ADDENDUM NUMBER 1:
CITY OF PORTSMOUTH, NEW HAMPSHIRE
RYE LINE WASTEWATER PUMPING STATION IMPROVEMENTS
CONTRACT DOCUMENTS AND TECHNICAL SPECIFICATIONS

Issued: August 21, 2008
For Bids Due: August 28, 2008

C-1a

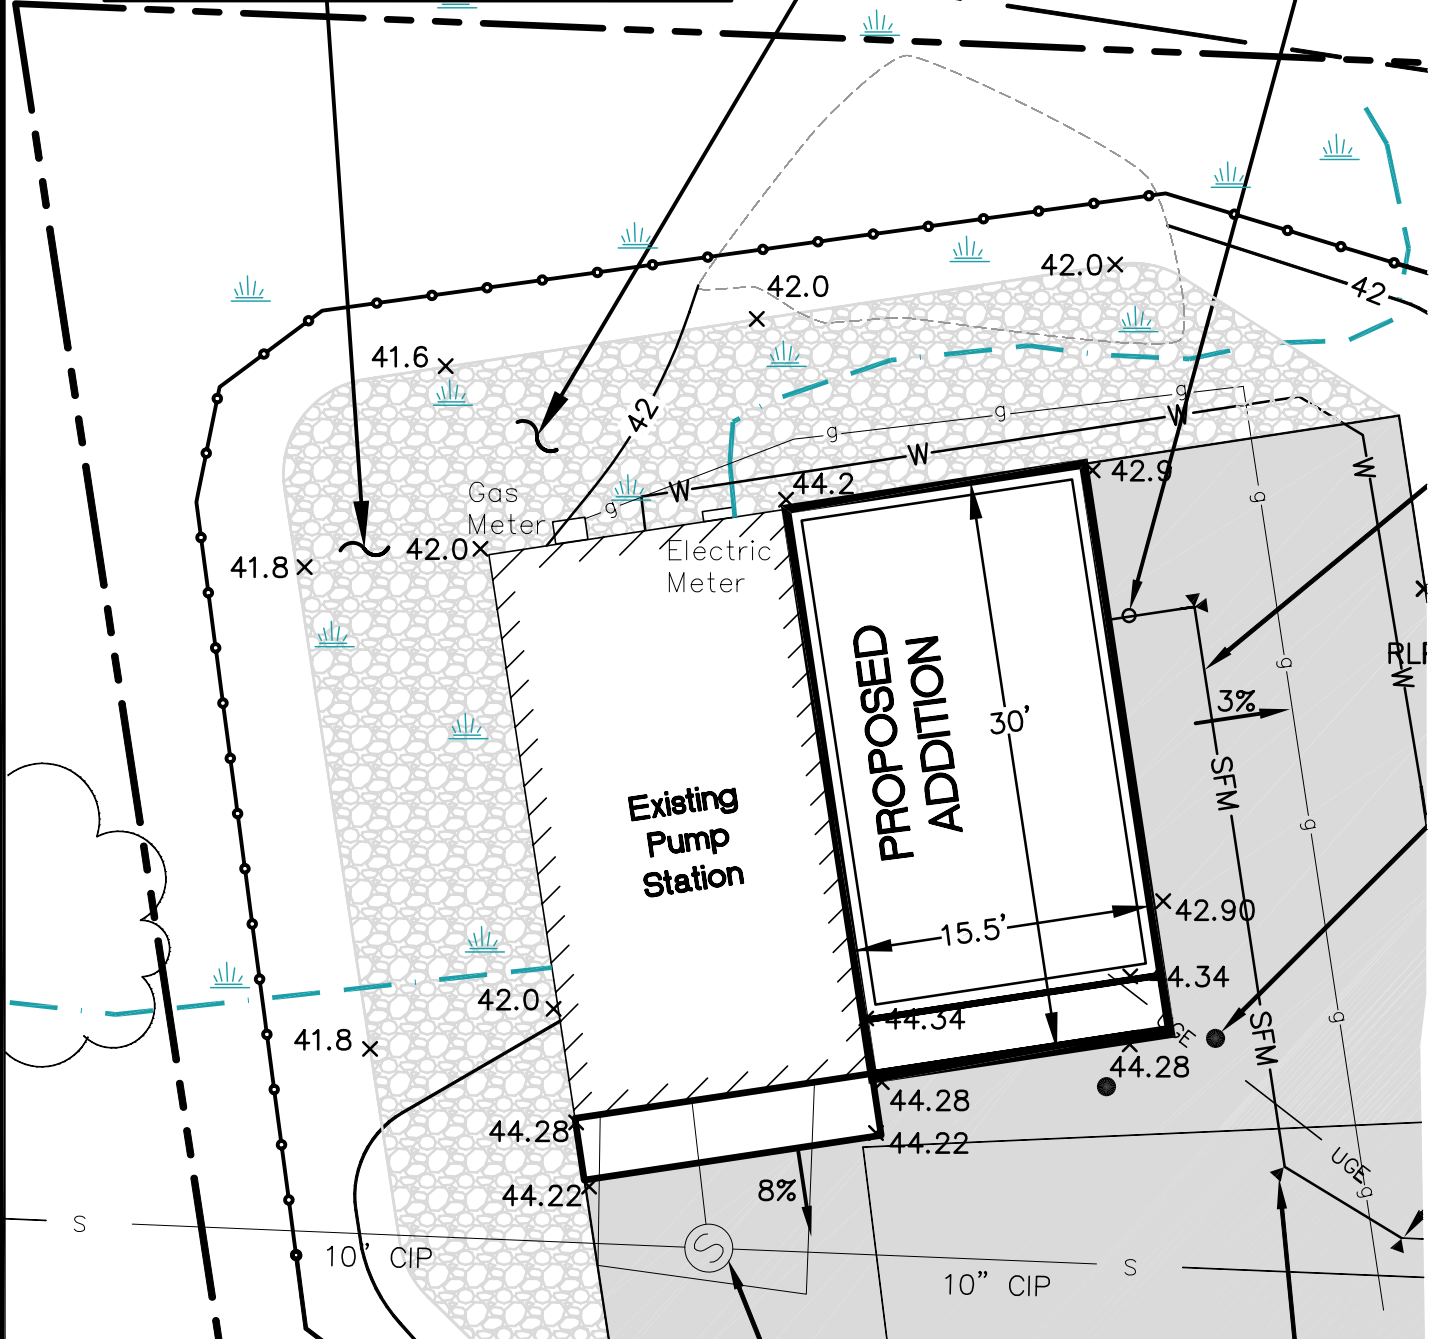
Sheet C-1 is modified as follows: The note describing how much material to excavate around the north and west sides of the station were modified. Please see the attached 8½ x 11 sheet showing this change, labeled C-1a.

CONTRACTOR TO REMOVE ~~X~~ 2' OF UNSUITABLE MATERIAL AND REPLACE WITH A 10 OZ. NON-WOVEN GEOTEXTILE FABRIC, ~~36"~~ OF BANK RUN GRAVEL (DEPTH VARIES), AND TOPPED WITH 6" OF 3/8" CRUSHED STONE TO MEET FINISHED GRADES

D-1a

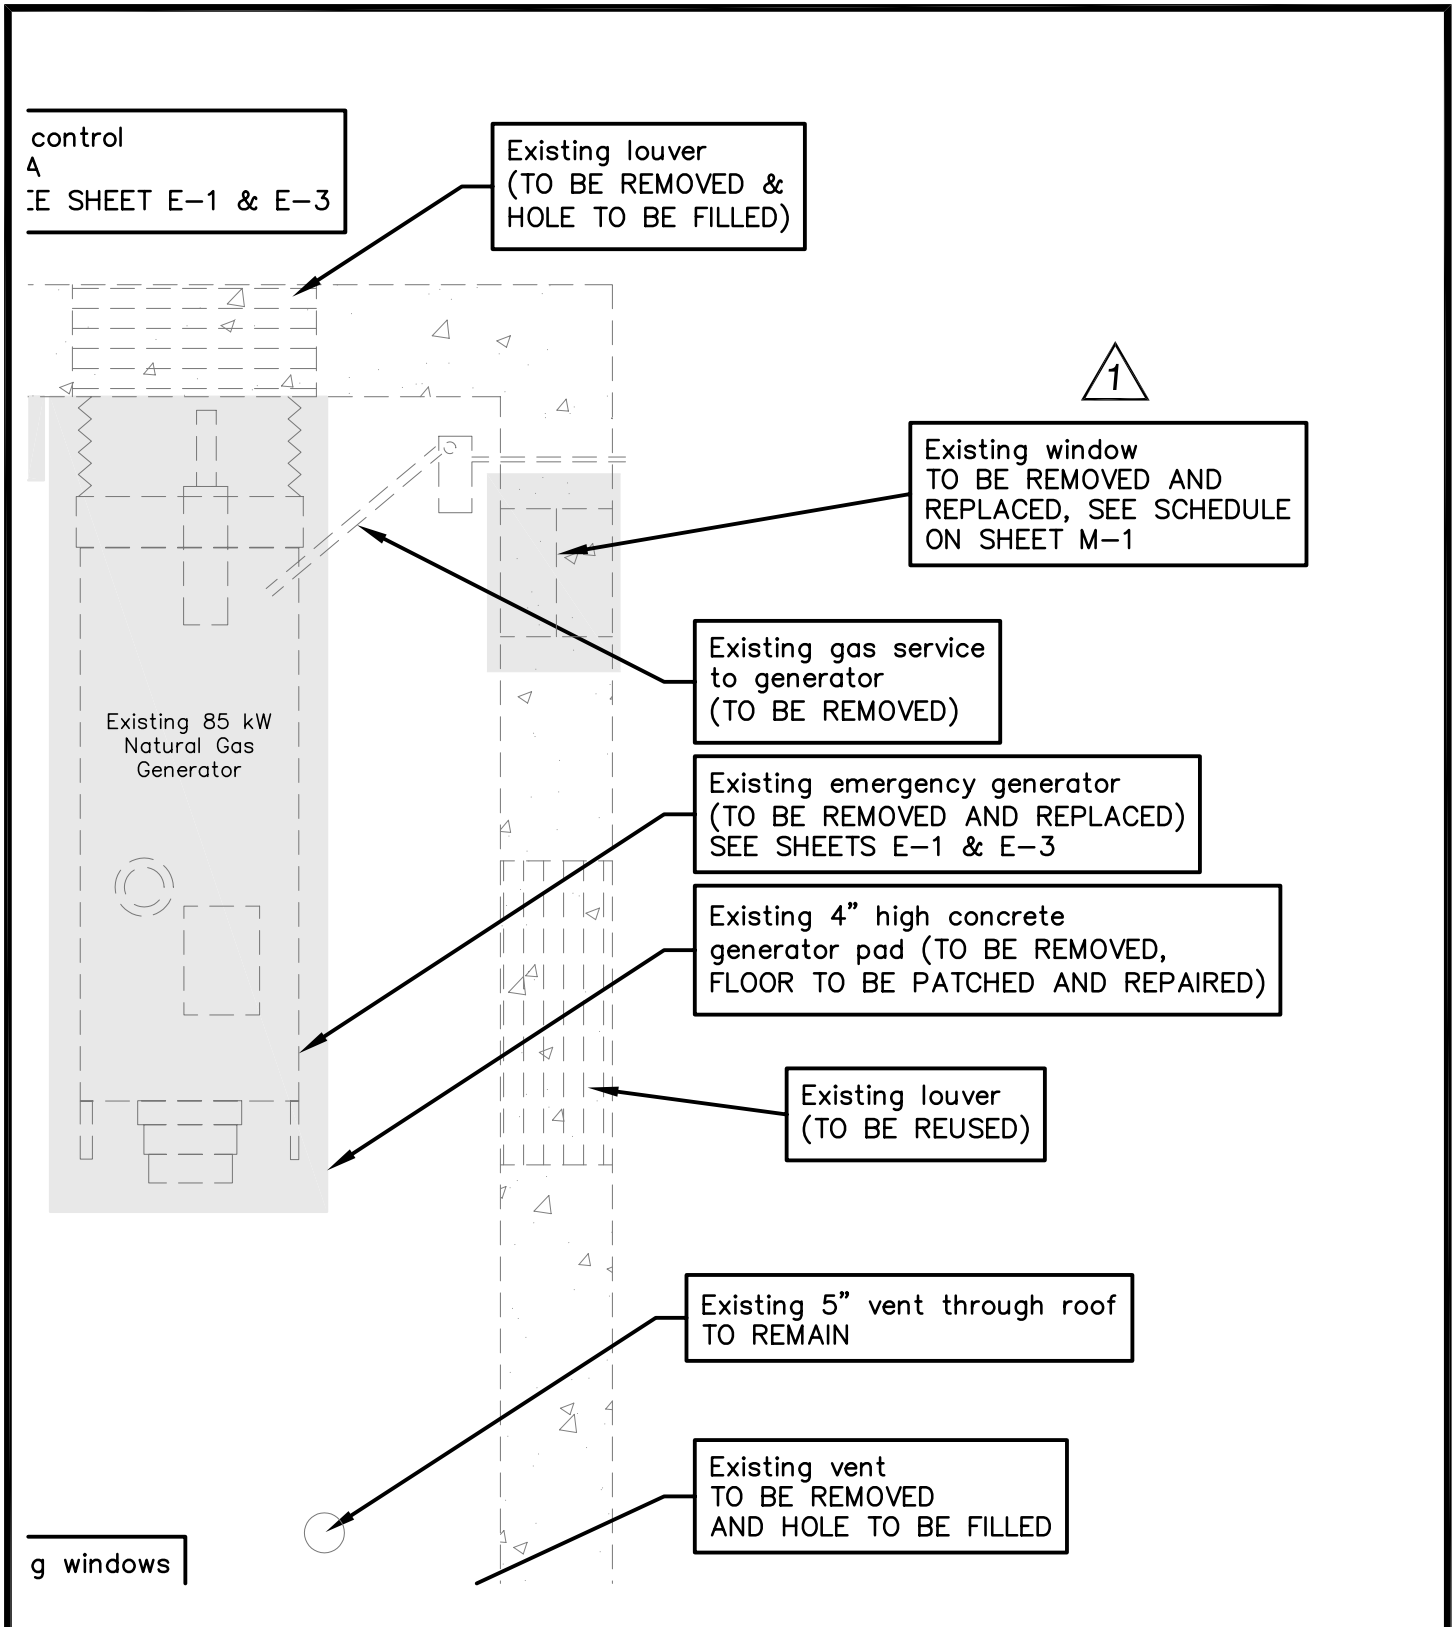
Sheet D-1 is modified as follows: Three (3) existing windows that were originally not proposed to be replaced now are. Please see the attached 8½ x 11 sheets showing this change, labeled D-1a and D-1b.

Existing window
TO BE REMOVED AND
REPLACED, SEE SCHEDULE
ON SHEET M-1

M-1a

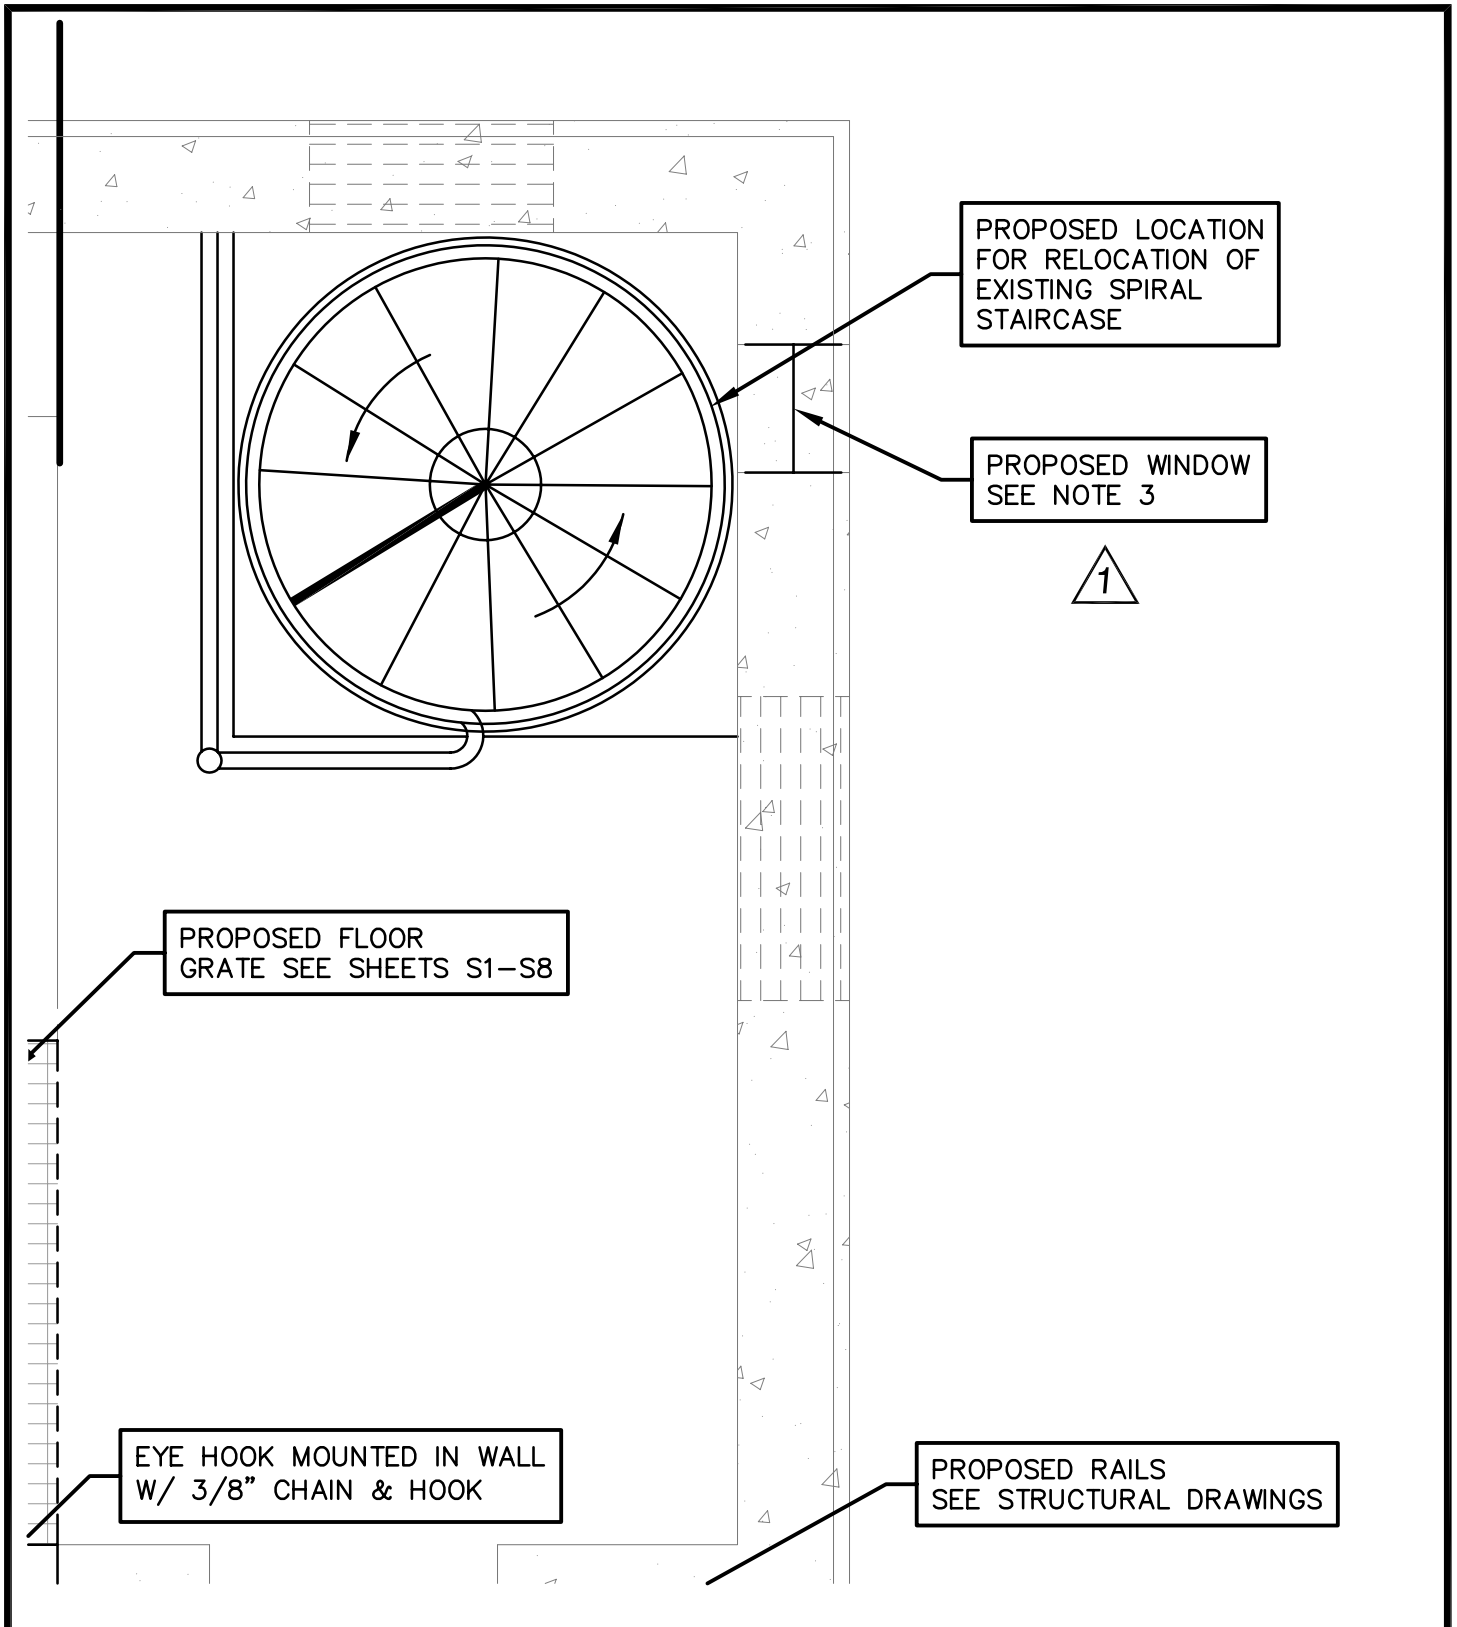
Sheet M-1 is modified as follows: A window schedule was added and (3) existing windows that were originally not proposed to be replaced now are. Please see the attached 8½ x 11 sheets showing this change, labeled M-1a, M-1b, and M-1c.

PROPOSED WINDOW
SEE NOTE 3

M-2a

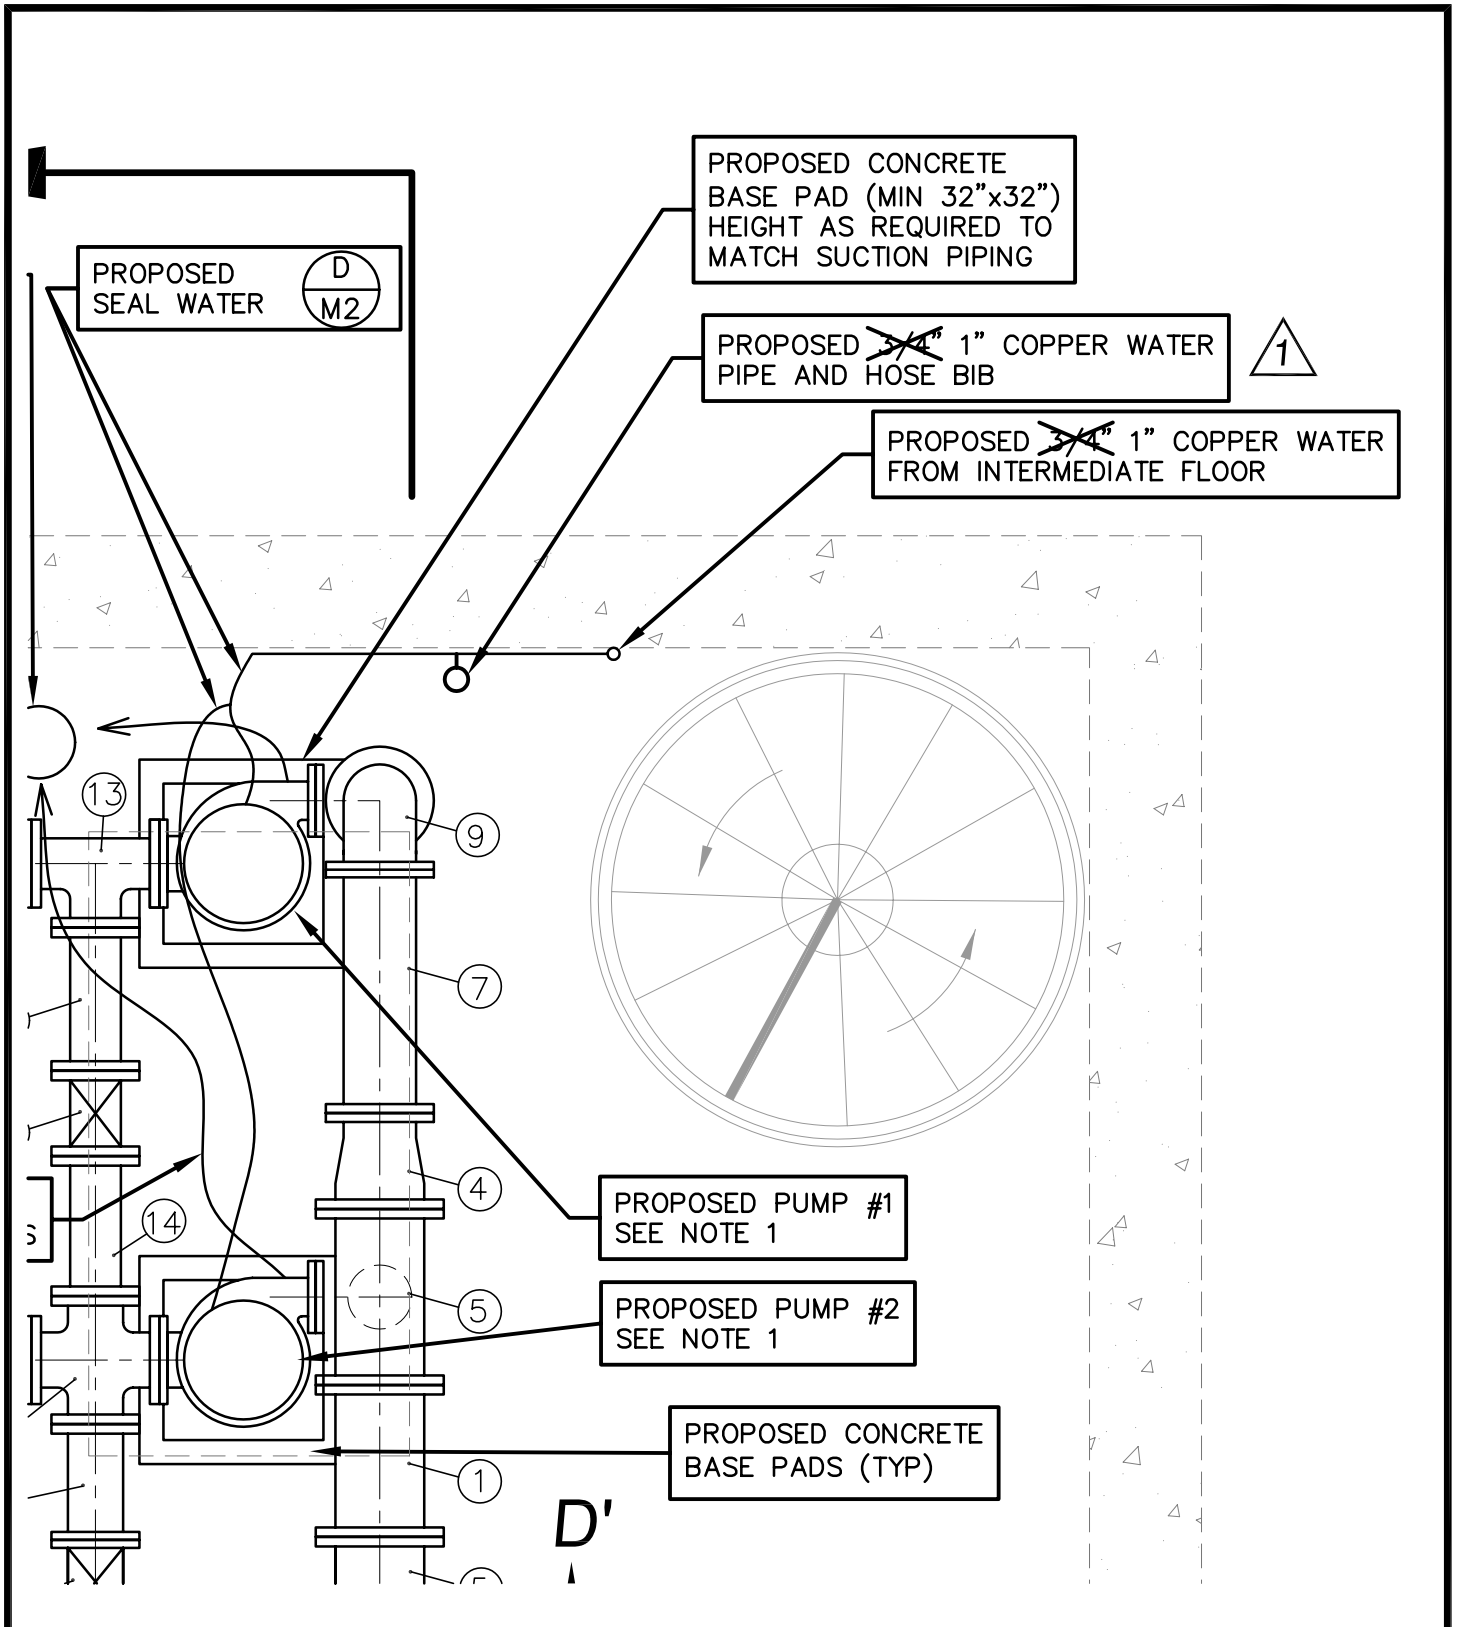
Sheets M-2 and M-3 are modified as follows: All water pipes that were ¾" were changed to 1". Please see the attached 8½ x 11 sheets showing this change, labeled M-2a and M-3a.
